Project [150093] - SR- 16 West Bound Nalley Valley
View Date 5/10/2010

To Tyron Bardwell WSDOT 11203 Bridgeport Way SW MS: WT-12 Lakewood, WA 98499-3002 Phone: (253) 589-6100 Fax: (253) 589-6101 From Mr Sam Hoelscher (Atkinson Construction) Subject Submittal 489.4 - Fire Supression System Shop Drawings	Date 5/10/2010 Items listed are being sent <input type="checkbox"/> Enclosed <input checked="" type="checkbox"/> Under Separate Cover Via Hand Delivered
cc Ms. Janet Lee (WSDOT)

RE: I-5 / SR 16 Interchange – Nalley Valley Bridge
Fire Standpipe System: Submittal Review

Fig. 910 - Swivel Sway Brace Fitting

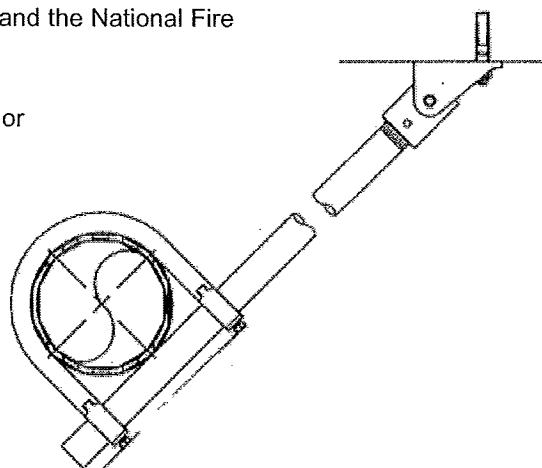
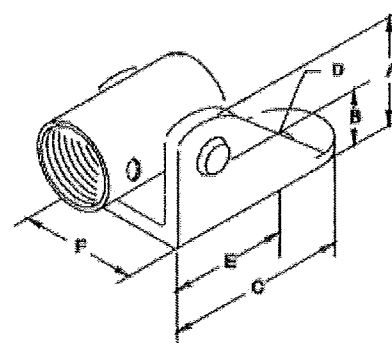
The Tolco Fig.910 Brace Structure Attachments has a 9/16" hole for attachment. It does not accommodate a 5/8" bolt. (Product data sheet attached). The 1/2" bolt into an Anvil Fig.282 concrete insert offers 1130 lb max load. The 5/8" bolt only offers 10 lbs more at 1140 lb max load. Because of the material limitations and the minimal value added to the strength we recommend using the 1/2" bolts as designed.

The longitudinal bracing attachments to the diaphragms using a post anchoring 1/2"x 2 1/4" deep Hilti KwikBolt3 provides tension strength of 1125 lbs. The 3/4" would provide more but again, the Tolco 910 will not accommodate it. We recommend using a deeper 1/2" KwikBolt3 such as the 3 1/2" deep bolt which affords 1895 lbs, if needed.
